Re: 1st Technical Submission Review – Landmark at Town Center – Site Plan and Final Plat
Application Number: **DA-1594-11**
Case Number: **2022-4007-00; 2022-3007-00**

1st Technical Submission Review

CROSS CREEK SUBDIVISION FILING NO. 4

VICINITY MAP
SCALE 1" = 1000'

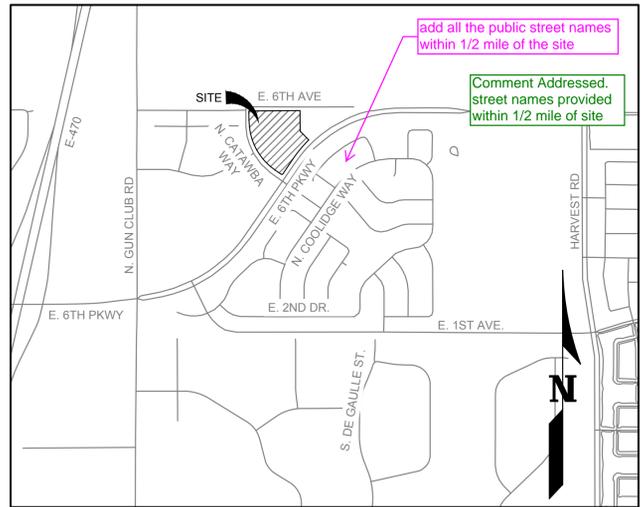
add all the public street names within 1/2 mile of the site

Comment Addressed. street names provided within 1/2 mile of site
